I. M. S. SUBDIVISION

The purpose of the application is to create two lots from a large metes and bounds parcel.

APPLICATION NUMBER 2 DATE July 6, 2006

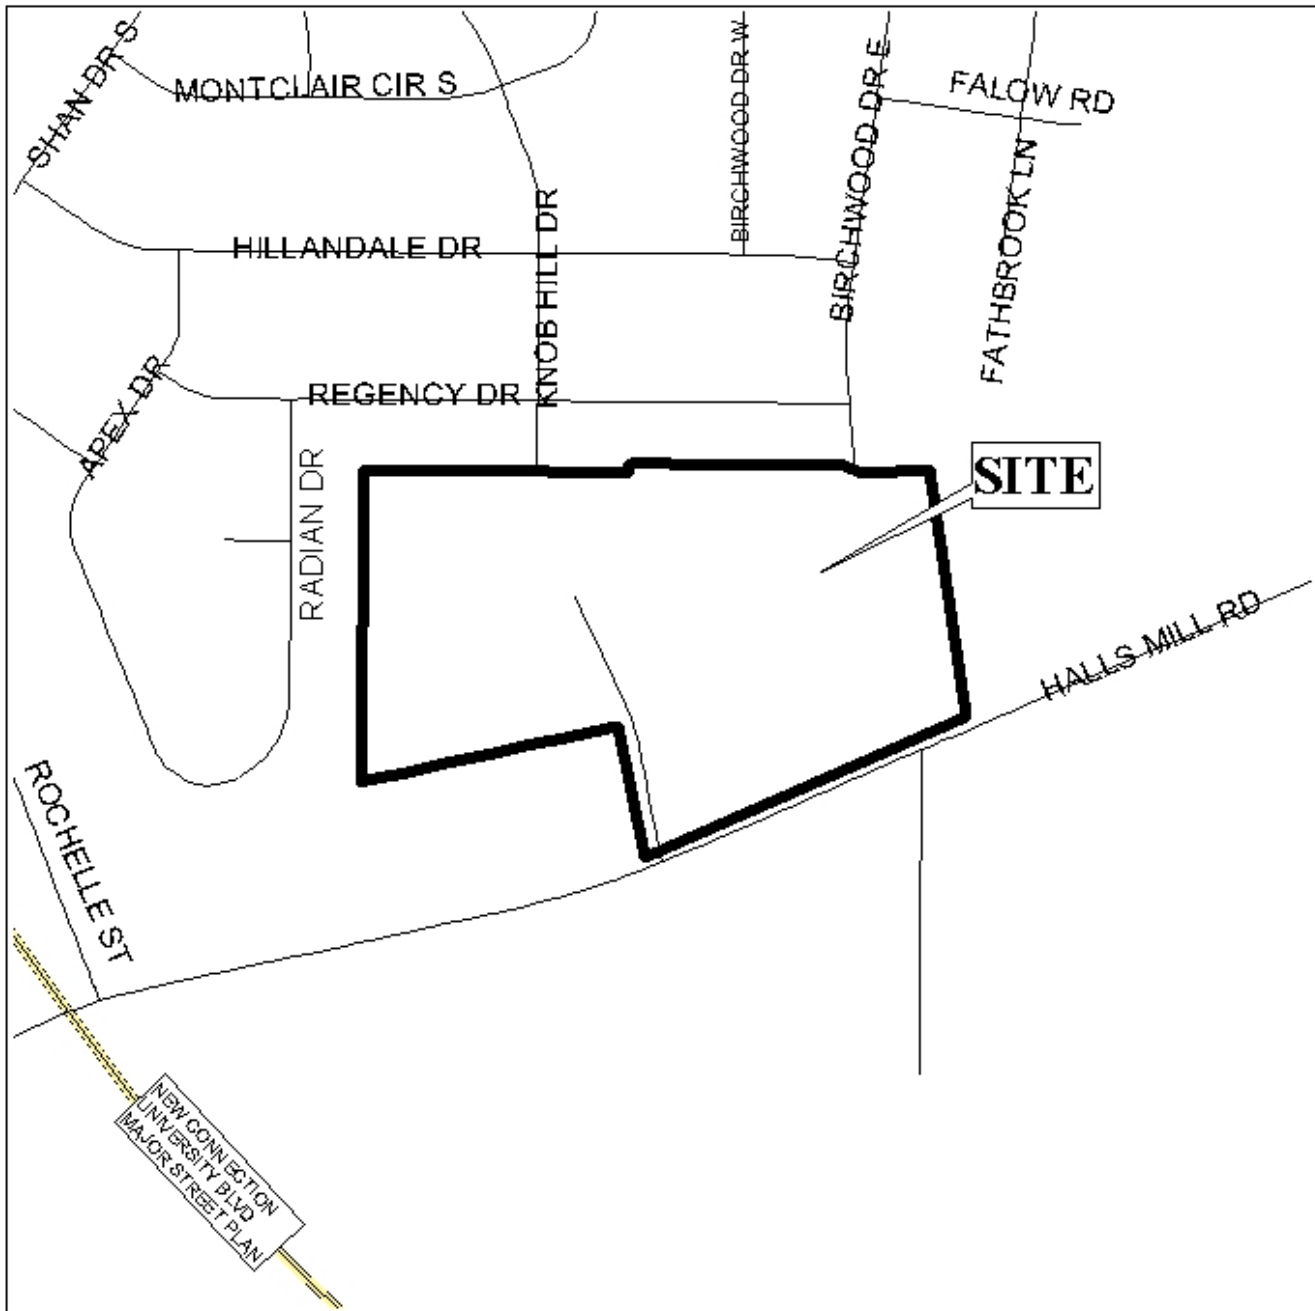
The plat illustrates the proposed 26.0± acre, two-lot subdivision which is located on the North side of Halls Mill Road, ¼ mile± East of Rochelle Street, and is in Council District 4. The site is served by public water and sanitary sewer.

The site fronts Halls Mill Road, a collector street with a varying right-of-way, which requires a 70-foot right-of-way along this portion. Therefore, dedication sufficient to provide 35 feet from the centerline of Halls Mill Road should be required. As a means of access management, the site should be limited to two curb cuts to Halls Mill Road for each lot. The site also adjoins the termini of Knob Hill and Birchwood Drives. There is an existing curb cut to Birchwood Drive, and an apparent unimproved access to Knob Hill. While these curb cuts should be allowed, the size, location, and design of future improvements will be subject to Traffic Engineering approval.

The site is presently developed with multiple buildings, including an apparent building connection crossing the two lots. This structure must be removed, and all buildings must be shown to meet minimum setbacks from the new property line, prior to signing the final plat. The 25-foot building setback lines are not shown, but would be required on the final plat, for all street frontages, and measured from the dedication.

The plat meets the minimum requirements of the Subdivision Regulations and is recommended for Tentative Approval, subject to the following conditions: 1) compliance with Engineering comments (Engineering recommends dedication of drainage easement at any location public water crosses property. Must comply with all stormwater and flood control ordinances. Any

work performed in the right of way will require a right of way permit. The applicant is responsible for verifying if the site contains wetlands. The site can be checked against the National Wetlands Inventory on the COM web site Environmental Viewer. If the site is included on the NWI, it is the applicant's responsibility to confirm or deny the existence of regulatory wetlands.); 2) compliance with Urban Forestry comments (Property to be developed in compliance with state and local laws that pertain to tree preservation and protection on both city and private properties (State Act 61-929 and City Code Chapters 57 and 64). Preservation status granted for all 50" and larger trees. All work under the canopies is to be permitted and coordinated with Urban Forestry, removal to be permitted by Urban Forestry only in the case of disease or impending danger. The removal of all Live Oak trees 24" or larger must be coordinated with Urban Forestry.); 3) dedication of sufficient right-of-way to provide 35 feet from the centerline of Halls Mill Road; 4) the placement of a note on the final plat stating that the site is limited to two curb cuts to Halls Mill Road for each lot, and a single curb cut each to Knob Hill and Birchwood Drives, with size, location, and design of future improvements subject to Traffic Engineering approval; 5) the removal of any structures crossing the property line or encroaching on the setbacks from the new line, prior to signing the final plat; and 6) the placement of the 25-foot setback lines on the final plat, measured from the dedication.
